Further Information

Proposed Temporary Public Vehicle Park (excluding Container Vehicle)
and Associated Filling of Land for a Period of 3 Years in "Agriculture" Zone,
Lots 1488 (Part) and 1489 (Part) in D.D. 83, Lung Yeuk Tau, Fanling, New Territories

(S.16 Planning Application No. A/NE-LYT/882)

Response-to-Comment (RtC)

DWG NO.	VER.
ANNEX 2 PLAN 01	001

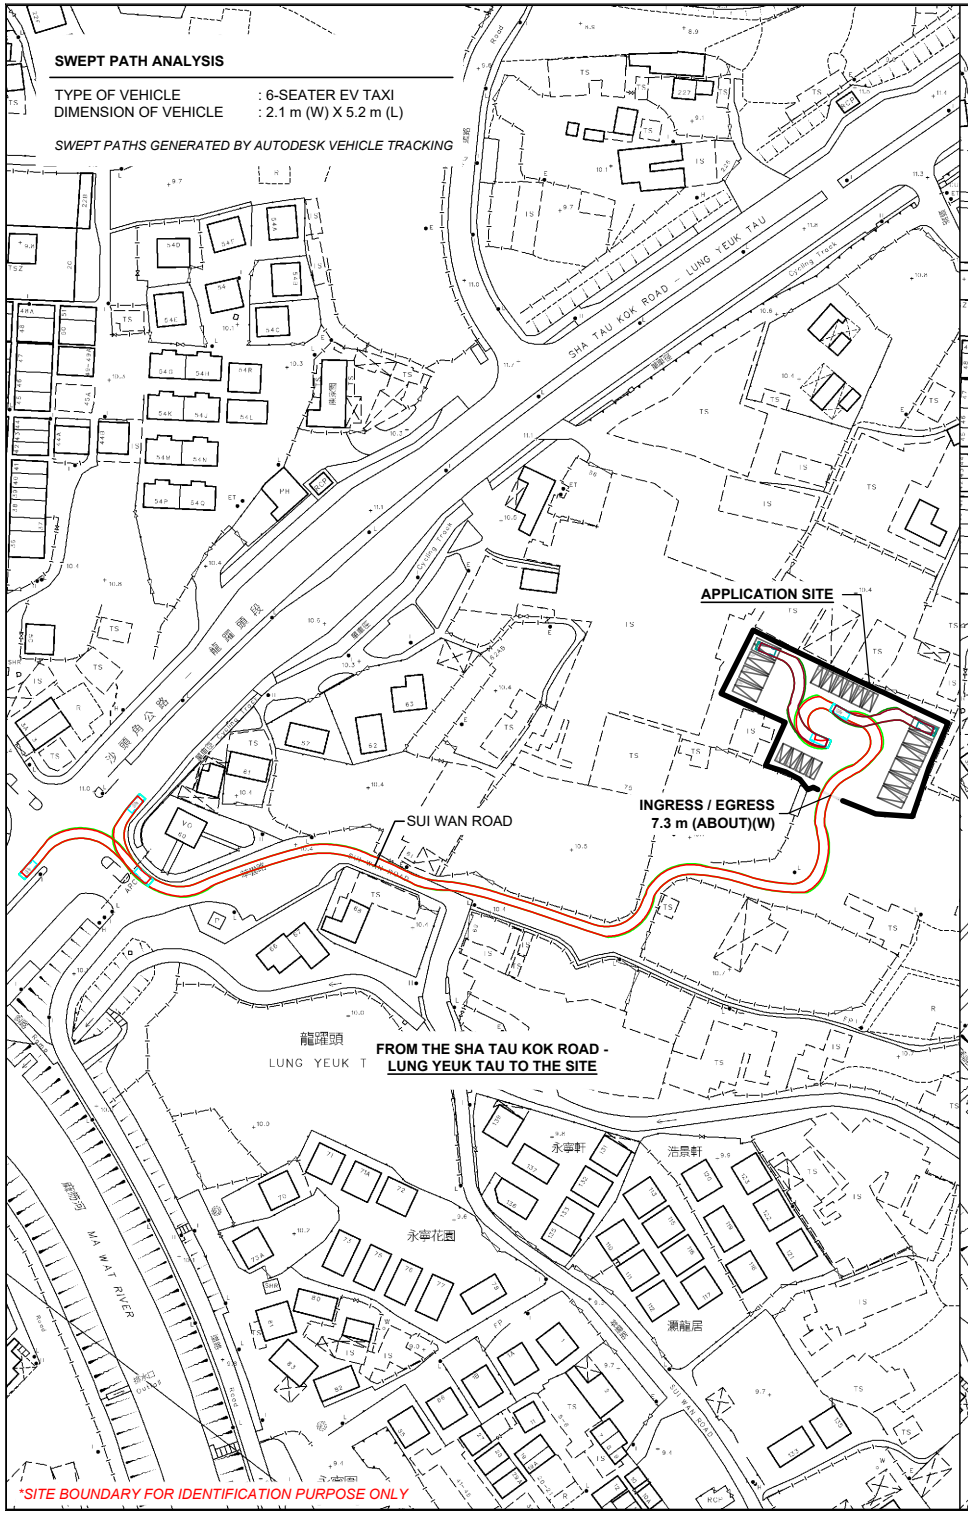
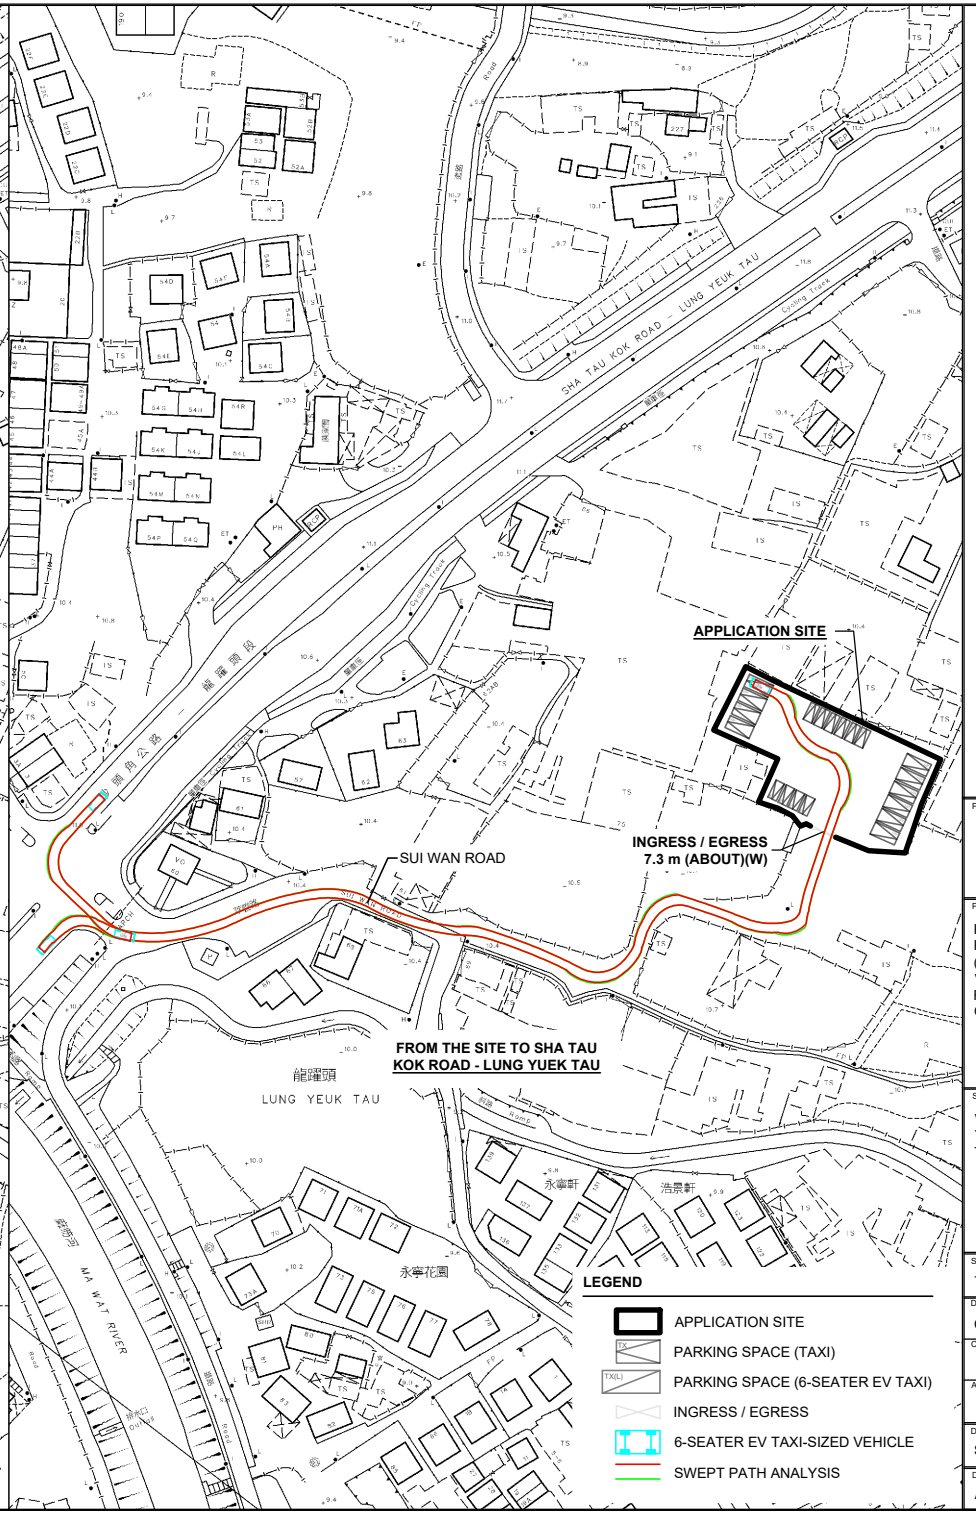
(d)	Swept path analysis should also be conducted for each type of parking spaces proposed.	Please refer to the swept path analysis conducted for taxi and 6-seater EV taxi at **Annex 2**.

- the swept path analysis at Annex 2 has demonstrated the smooth manoeuvering of vehicles along the access road between the Site and Sha Tau Kok Road – Lung Yeuk Tau;

DWG NO.	VER.
ANNEX 3	001

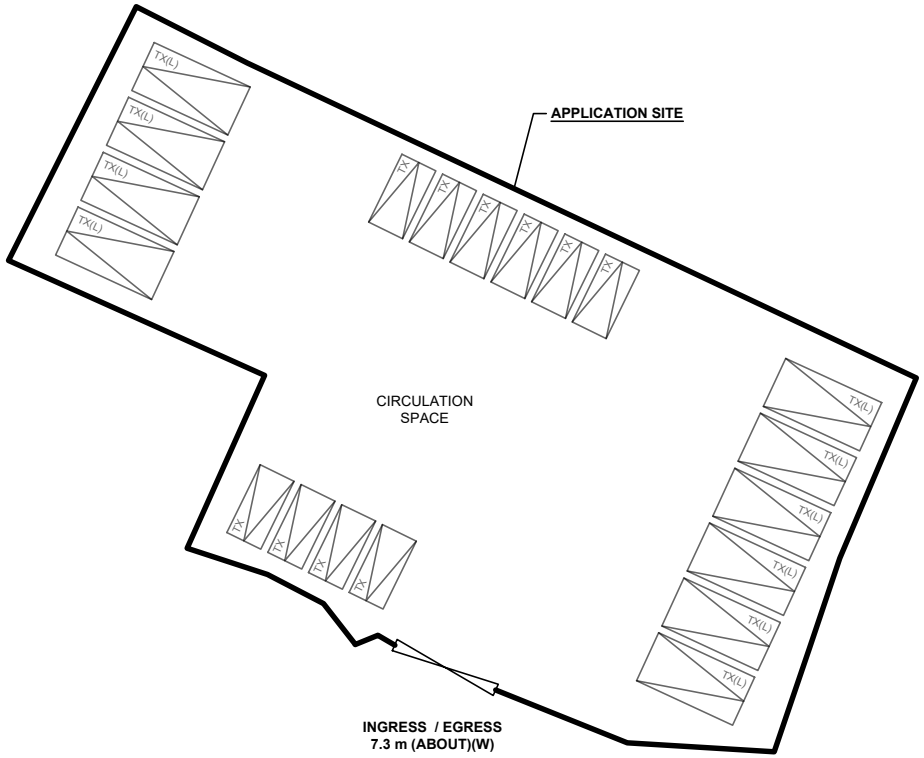
Departmental Comments		Applicant's Responses
2. Comments of the Commissioner for Transport (C for T)		
(a)	It is noted that the Site is proposed to provide parking spaces for the taxi fleet. However, there are 10 nos. of parking spaces of light goods vehicle (LGV) proposed within the Site. Please explain.	The applicant's fleet comprises various vehicle models. According to the applicant, the body dimension of the largest model (the Premium 6-seater Electrical Vehicles (EV) (specifications enclosed at **Annex 1**) measures 5,490 mm (L) × 1,980 mm (W) × 2,050 mm (H), which would make normal private car parking spaces insufficient to cope with. As such, the applicant opts to sacrifice the number of parking space by converting some of those into larger parking spaces, so as to allow more spaces for the safe manoeuvering of vehicles within the Site.

(a)	With the reference to TD's comments as detailed above and the dimensions for standard parking space for taxi as set out in Table 11 of the Hong Kong Planning Standards and Guidelines (HKPSG) Chapter 8, please justify the proposed provision of 10 LGV-sized parking spaces at the Site.	Please refer to the applicant's response to C for T in Section 2(a) of this table.

(ii) The applicant provides the revised layout plan and revised pages of the Form No. S16-III (**Annex 3**) to clarify the types of parking spaces proposed in the current application.

NO. OF TAXI PARKING SPACE	: 10
DIMENSION	: 5 m (L) x 2.5 m (W)
NO. OF 6-SEATER EV TAXI PARKING SPACE	: 10
DIMENSION	: 7 m (L) x 3.5 m (W)
